June 12, 2006 (*Corrected August 3, 2006)

UTAH DEPARTMENT OF TRANSPORTATION

SUBJECT: Standards Committee Meeting Minutes and Next Meeting

BOUNDARY SURVEY

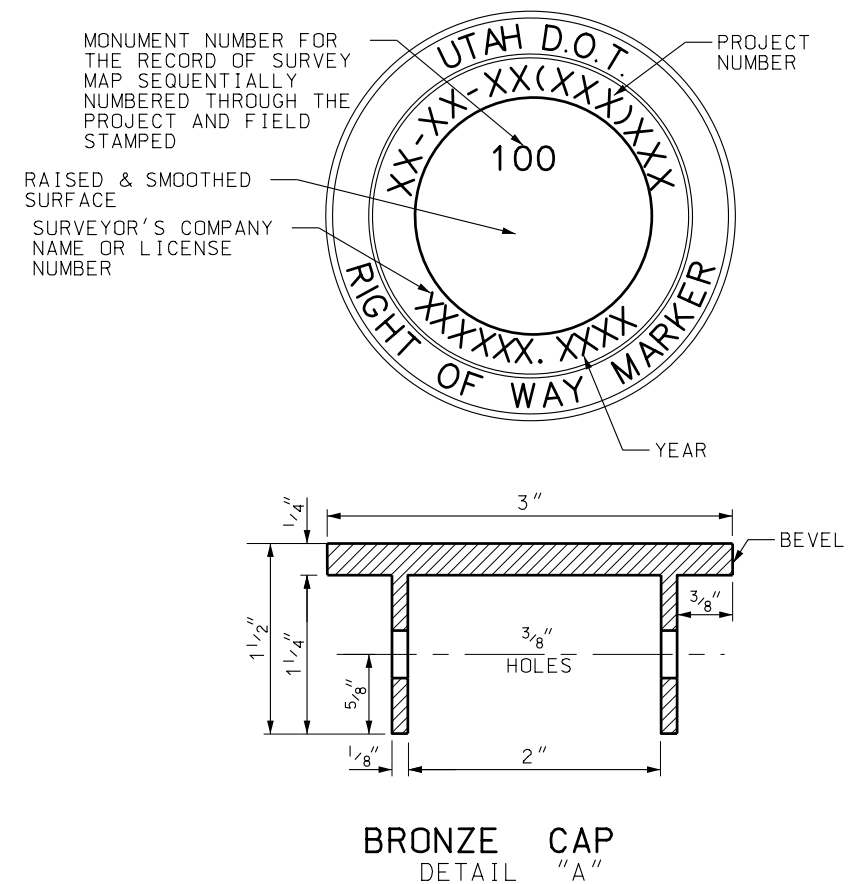
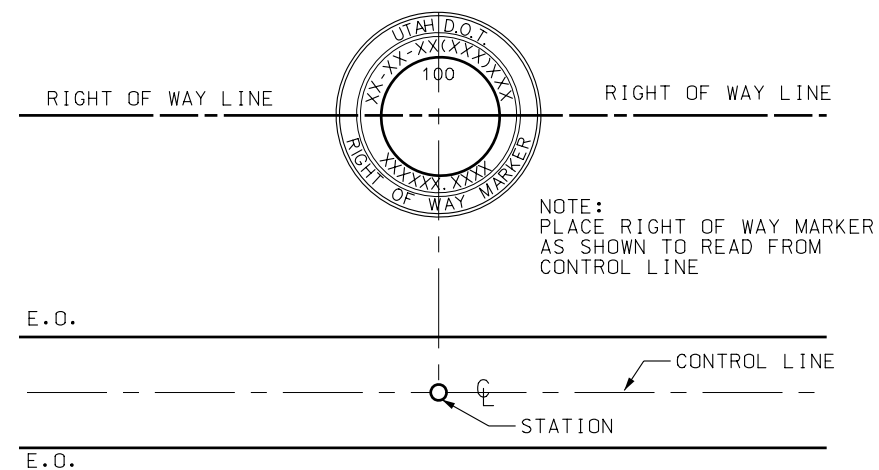
Drawing GW 6, note number 8.

Delete Article 3.1, paragraph A and replace with the following:

- A. Place Right-of-Way Markers in accordance with GW series Standard Drawings.
Stamp onto each Right-of-Way Marker:
 - 1. Right-of-Way marker number
 - 2. **Exact control point mark location to within 0.01 feet (center punch or “dimple”)**
